Keithley Instruments
28775 Aurora Road
Cleveland, Ohio 44139
1-800-833-9200
tek.com/keithley

Model 2450 Interactive SourceMeter® Instrument, 2450-NFP, 2450-RACK, 2450-NFP-RACK

VERSION 1.7.3 RELEASE

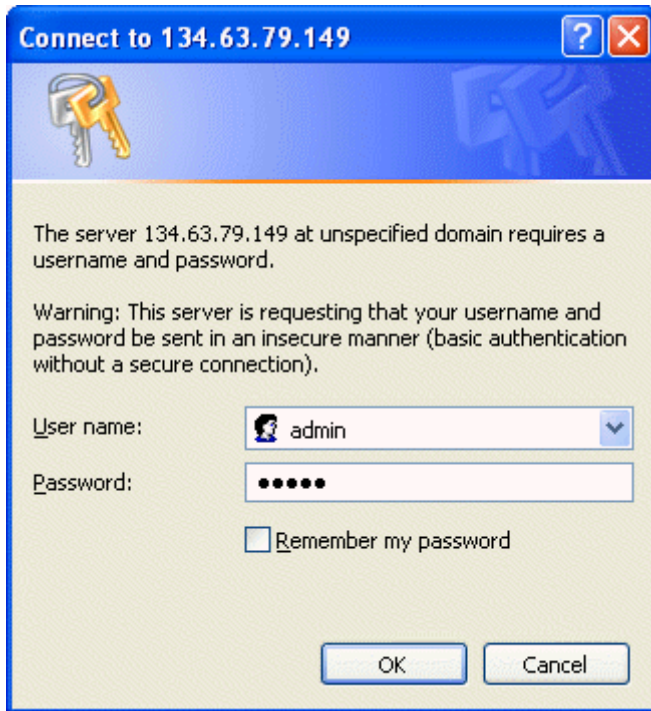
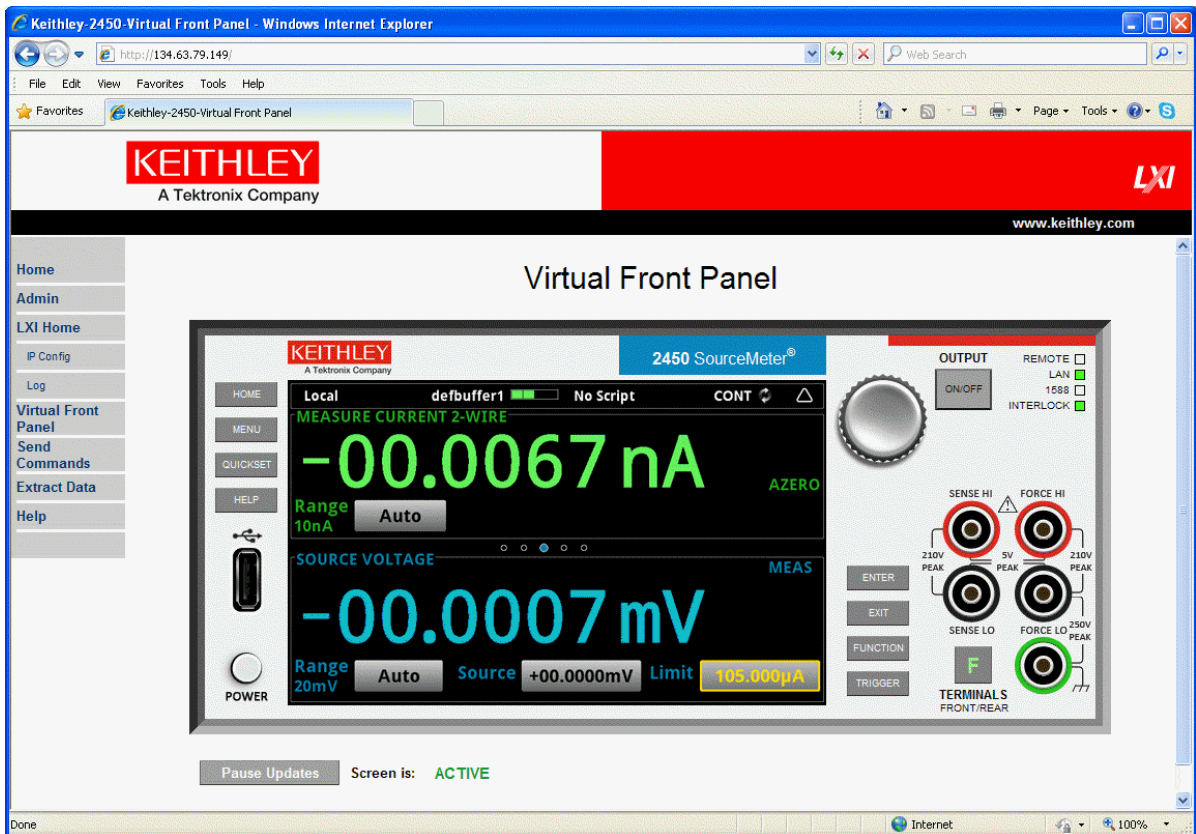
Implement new Virtual Front Panel capability.

To access the new Virtual Front Panel, access the 2450 through Ethernet using your favorite Internet browser.

When asked for a Username and Password: enter the Username and Password for that particular 2450. The default Username is admin and the default Password is admin.

An example of the 2450 Virtual Front Panel is shown below. Users can use their mouse from a standard PC to control the instrument. Users can also use touch screens from most touch screen devices that can access the 2450 IP address.

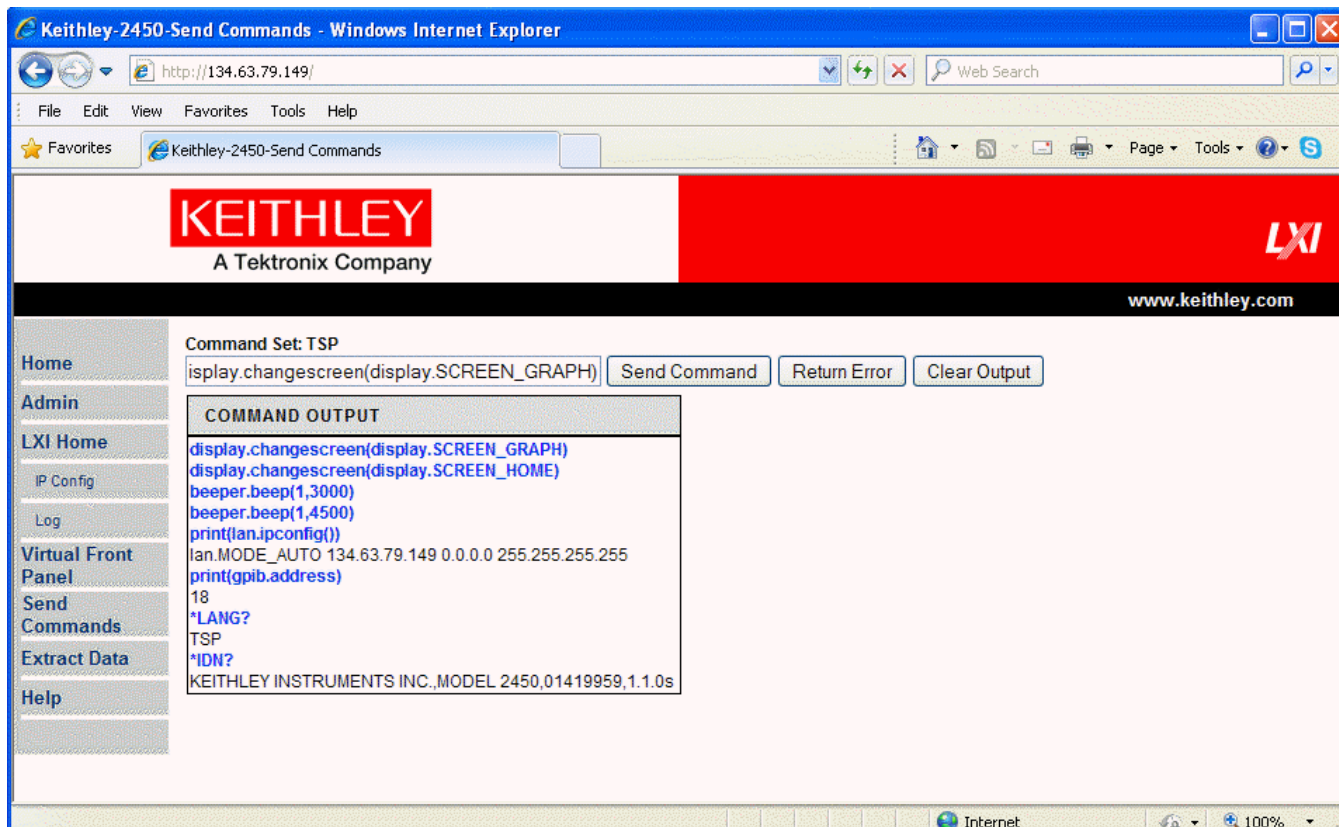
The behavior of the *LANG? command on the 2450 has been changed as follows.

Sending the query *LANG? over a non-controlling interface will no longer change the interface control of the unit. For example, if the unit is under local control, then sending the *LANG? over Telnet, USB, or GPIB will leave the unit under local control. This was done in order for KickStart (or any other remote control software) to query connected/accessible instruments without resetting them or changing or disturbing the current trigger model.

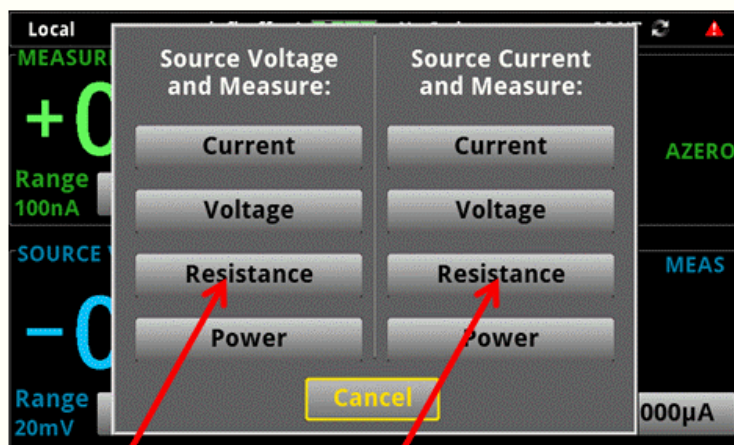
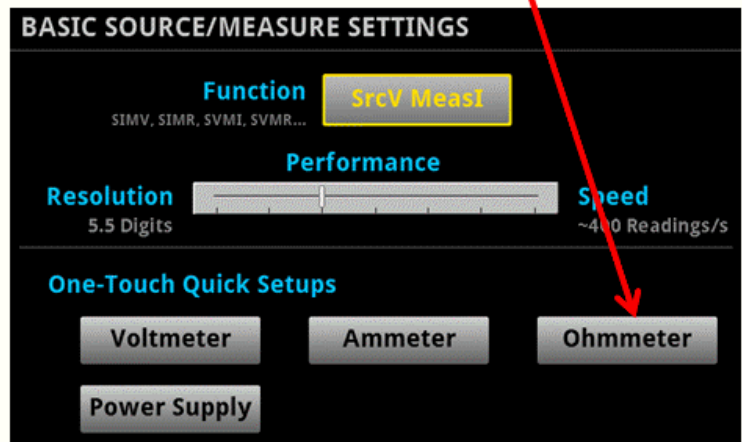
- g. New SCPI Command Usage:
 - i. "Manual Ohms" (see definition above)
 - SOURce:FUNC VOLTage
 - [SENSe[1]]:FUNC "CURREnt"
 - [SENSe[1]]:CURREnt:UNIT OHMOR
 - SOURce:FUNC CURREnt
 - [SENSe[1]]:FUNC "VOLTage"
 - [SENSe[1]]:VOLTage:UNIT OHM
 - ii. "Auto Ohms" (see definition above)
 - [SENSe[1]]:FUNC "RESistance"
- h. Front panel user interface setting of Manual vs. Auto Ohms measurements
<see the following figure for details>

Both exhibit "Manual" Ohms behavior (works just like Power by setting units to Ohms and going to SVMI or SIMV)

Exhibits "Auto" Ohms behavior
